Docket Items # 8 & 9
BAR CASE # 2015-00036 & 2015-00037
BAR Meeting
March 18, 2015

ISSUE: Permit to Demolish and Alterations

LOCATION: 535 North Columbus Street

STAFF RECOMMENDATION

ELEVATIONS

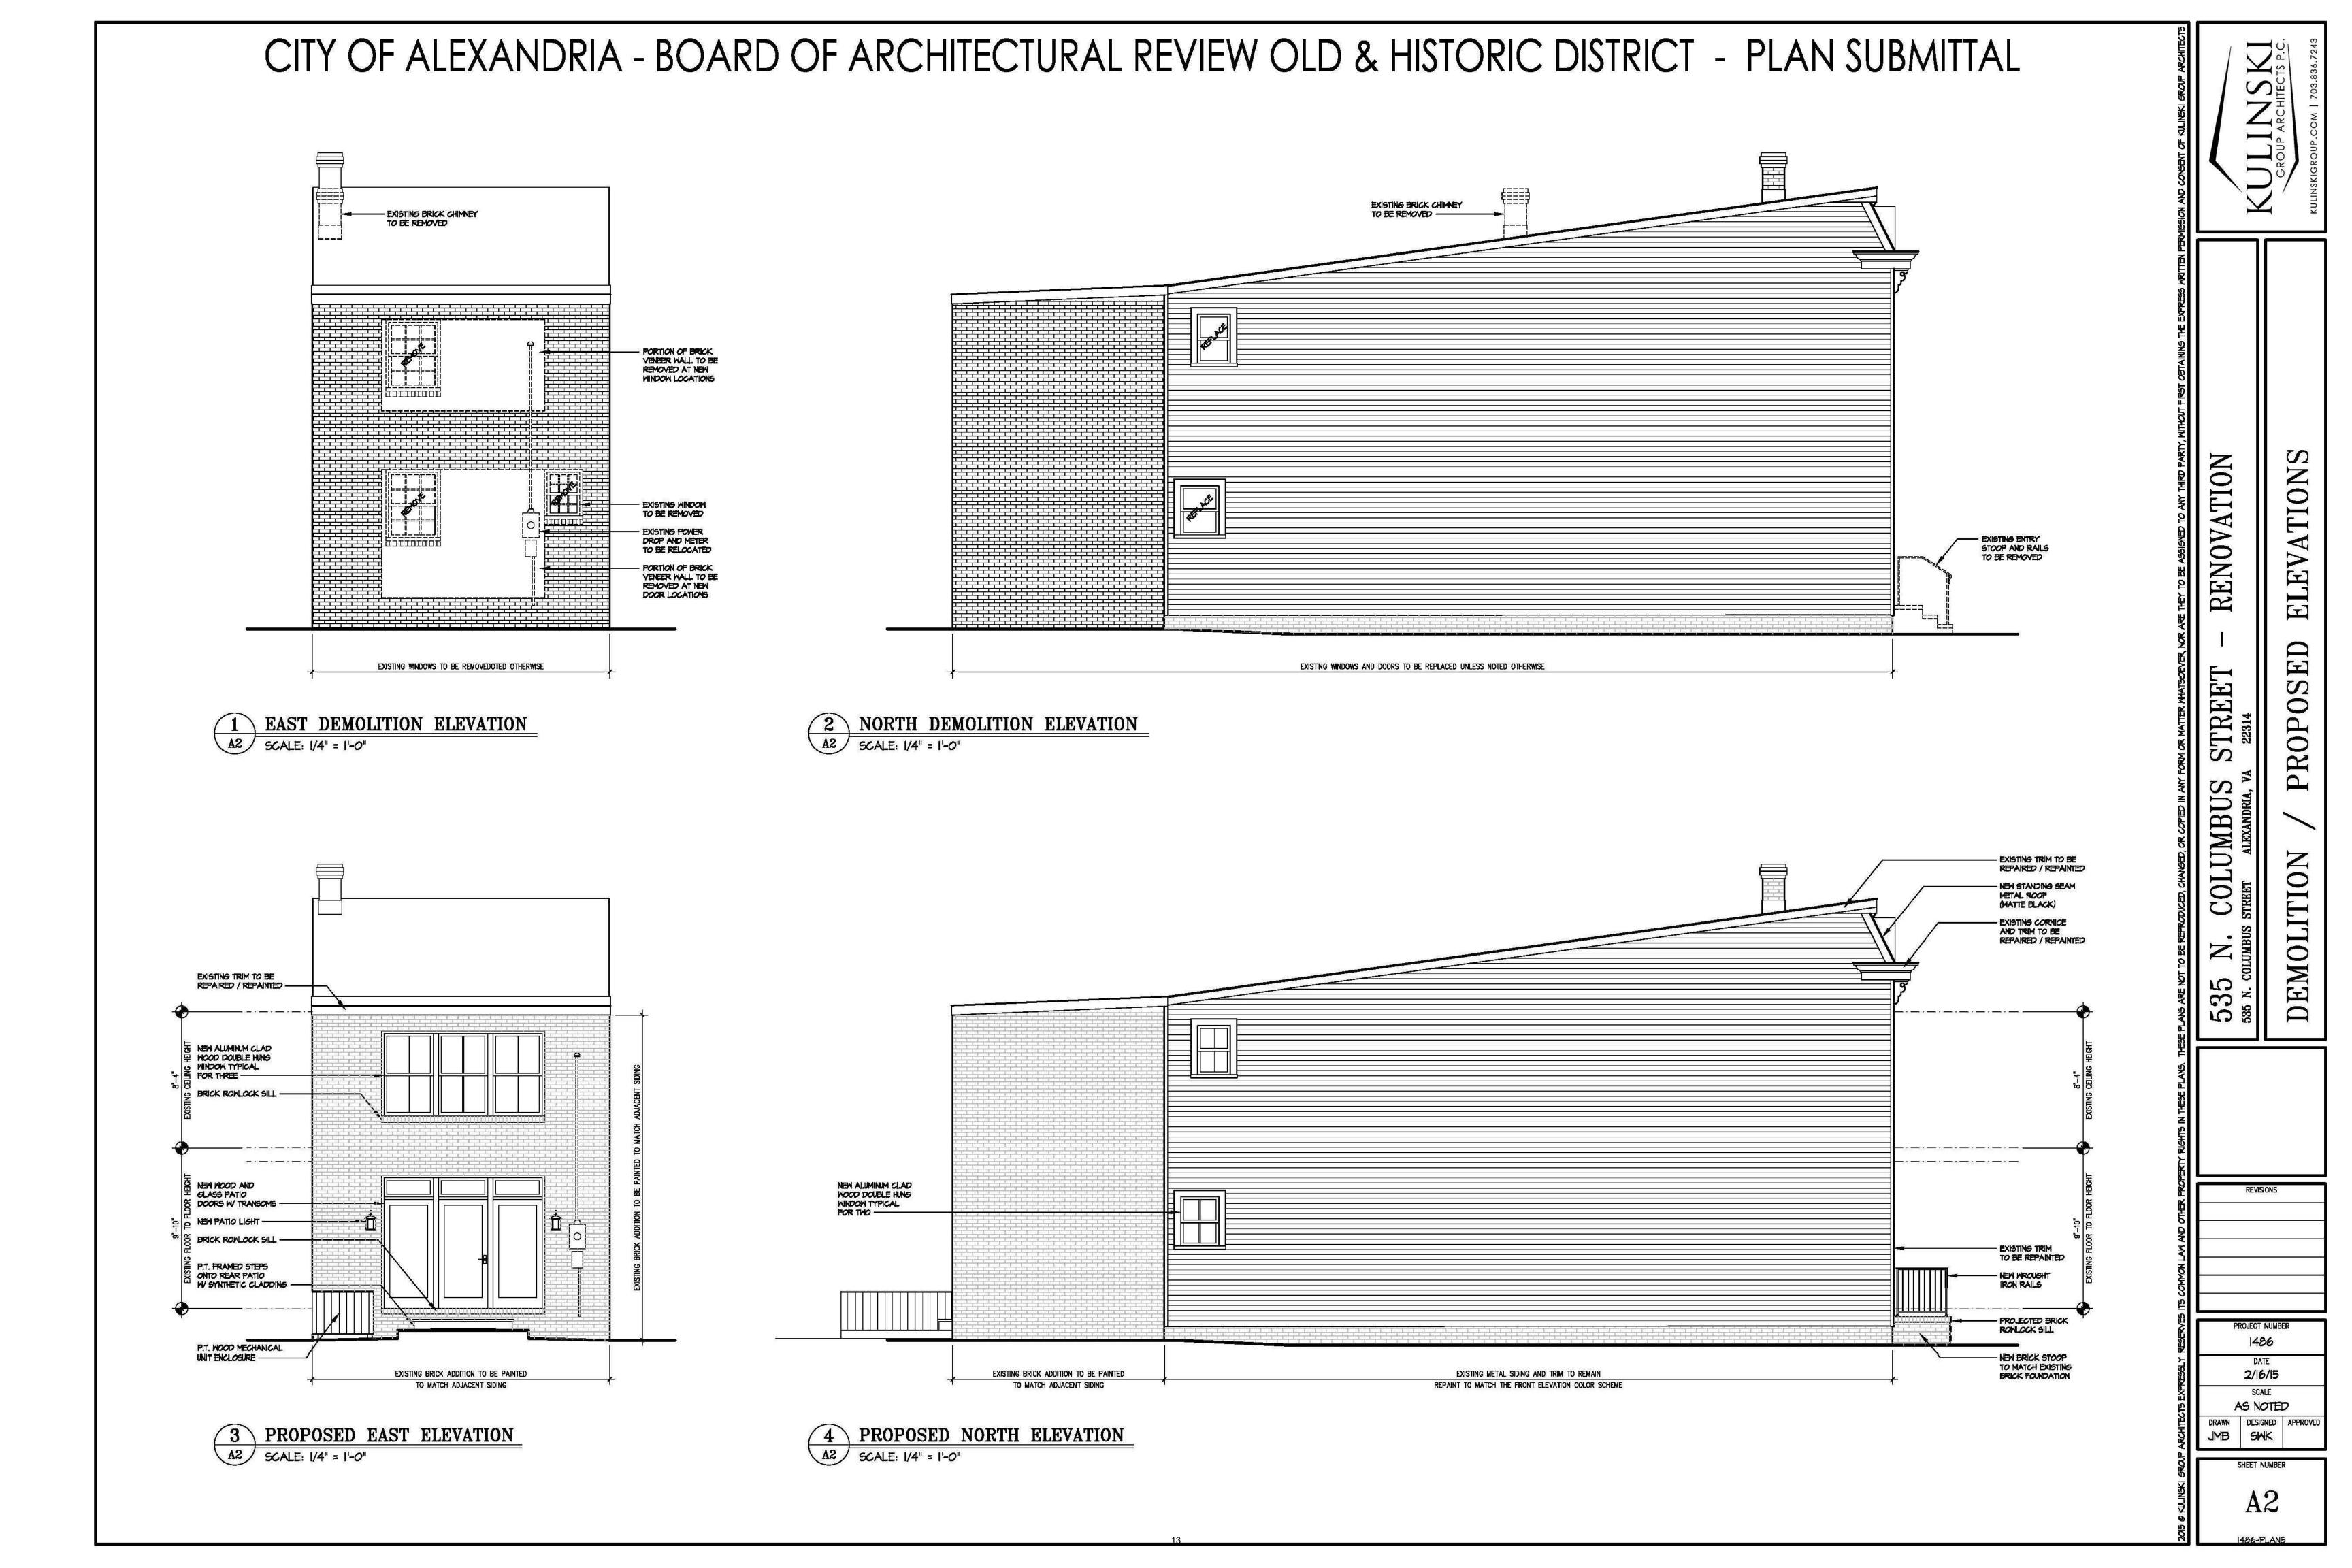
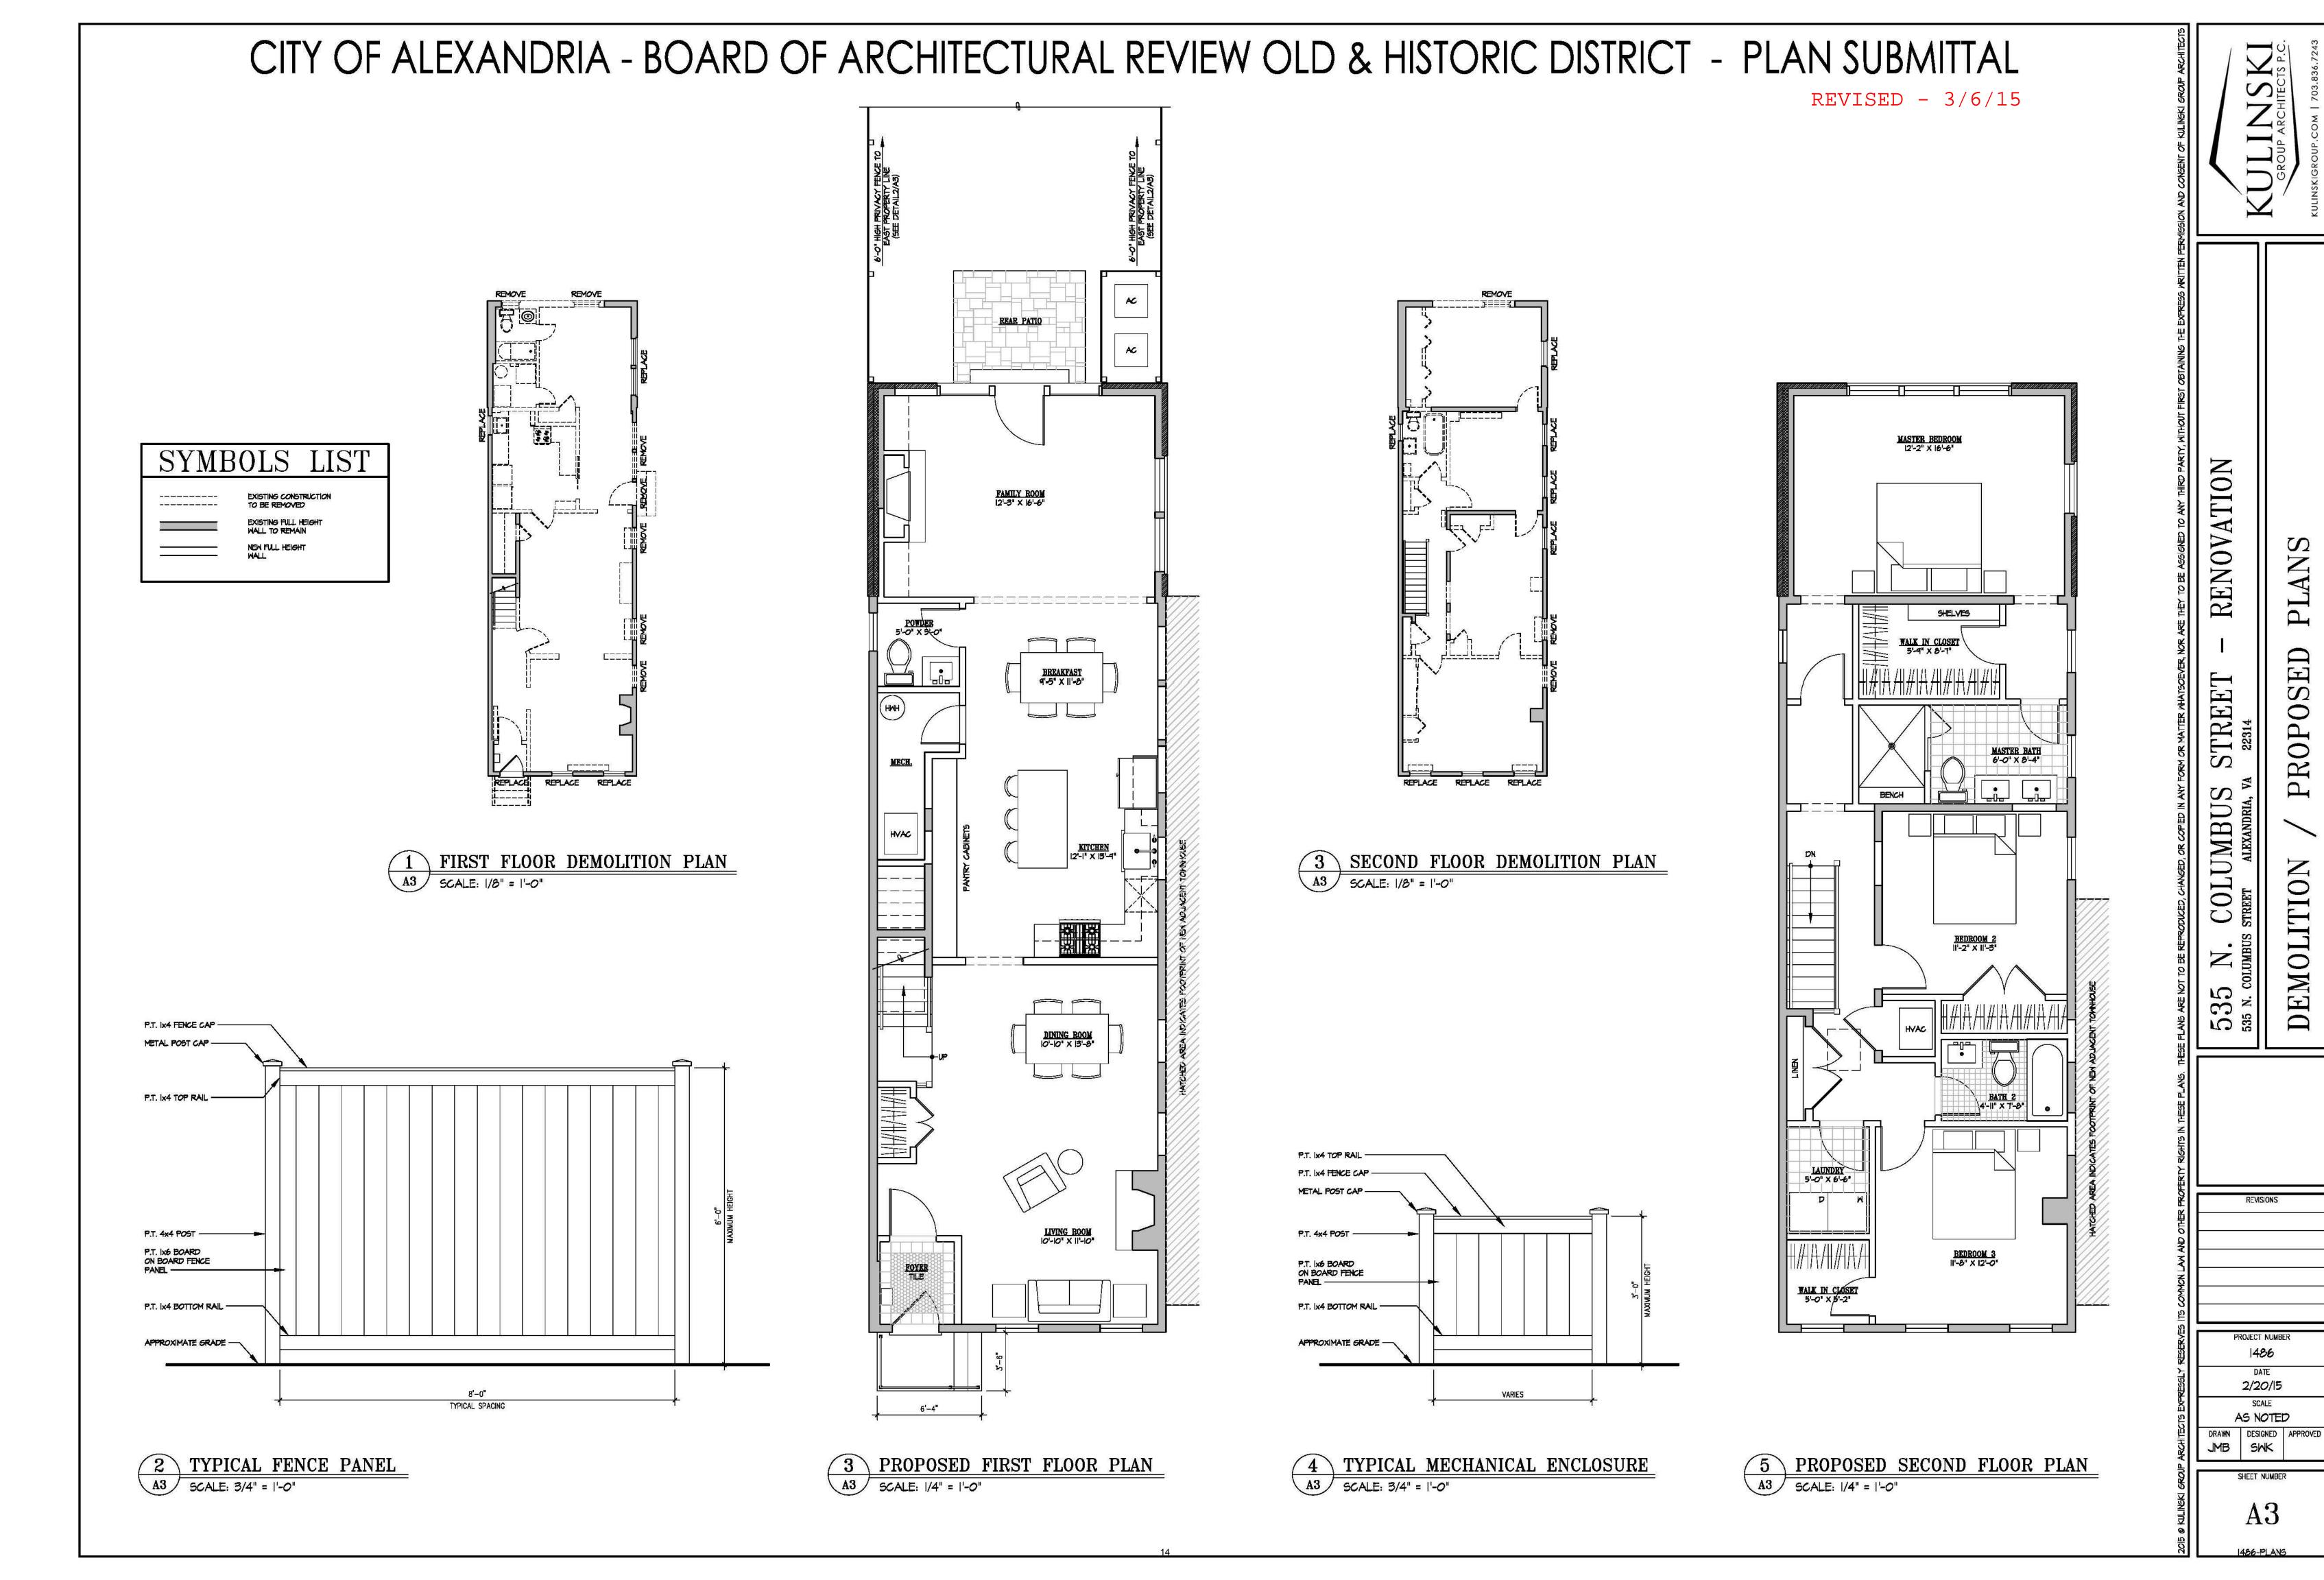
generally have ordinary or common features or elements. In this case, the applicant is proposing to remove five (5) original windows, the original front entry surround and transom, the historic wood siding on the side elevations and one original chimney in order to renovate and reconfigure the exterior and interior living spaces to accommodate the construction of a new house on the adjacent lot. Staff supports the removal of the windows on the south elevation for the construction of the adjacent house, as this infill is consistent with the historic development pattern within the district. However, staff opposes removal of the chimney, the entry surround and transom and the wood siding on the side elevations, as this amount of demolition will compromise the building's historic integrity and is at odds with the Boards adopted policies and *Design Guidelines*. In addition, staff finds that removal of these exterior features is not necessary to achieve the applicant's design goals.

Finally, during staff's site visit to the property, the original masonry chimneys appear to be from the first period date of construction and utilize a traditional corbelled form. The *Design Guidelines* state that "chimneys can have an important impact on the overall visual composition of a building" and encourage their "maintenance in situ" and discourage their removal without a "compelling reason and substantial justification." For these reasons staff strongly supports the retention of the portion of both chimneys above the roofline as character-defining features of the original building mass, thought staff notes that the chimney proposed for demolition is in the center of the structure and will not be easily visible once the abutting new house is constructed.

In staff's opinion, none of the criteria for demolition and encapsulation are met and the Permit to Demolish/Capsulate should be granted, provided that the applicant retain the front door surround and transom, the wood siding, and the portion of the brick chimneys above the roofline.

Through research and existing conditions, we know that most mansard roofs on Late Victorian buildings were clad with either decorative slate or wood shingles or with stamped metal shingles. Standing seam metal roofs were a more typical treatment on hipped or gable roof forms, not mansard roofs, and staff is not aware of any small mansard roofs in the district that have original standing seam roofing. As such, staff recommends that the front mansard roof have metal shingles or decorative slate or wood shingles.

Finally, the applicant is proposing a simple wrought iron handrail with guardrail to be installed on the front stoop. Discussions with Code Administration staff has confirmed that the current 2012 Virginia Building Code only requires a handrail on a continuous run of treads or flights with four or more steps. In addition, a guard is not required if the landing and steps are 30" or less above grade the stairs.³ Per the submitted plans the proposed brick stoop's landing is 19" above grade. Therefore, neither a railing nor a guard is required. However, due to the proposed orientation of the stoop, staff is recommending that the design be altered to a simple handrail without balusters, so that the railing does not compete with the design of the historic entrance.

- 1. The historic central brick chimneys are not removed above the roofline.
- 2. Upon removal of the metal siding, staff will evaluate the condition of siding for repair or replacement per the BAR's siding policy. If the siding cannot reasonably be retained, new wood siding must be used on the side elevations per the Board's policy.

- 5. Staff will survey the mansard portion of the roof to determine its original material for replacement, per the Board's roofing policy. If the original material cannot be determined, it may be clad with metal shingles, or fancy cut decorative slate or wood shingles.

- 6. The guardrail balusters will be eliminated from the wrought iron railing on the new, front brick stoop.
- 7. The new rear fence be painted or stained and constructed of wood or wood composite.
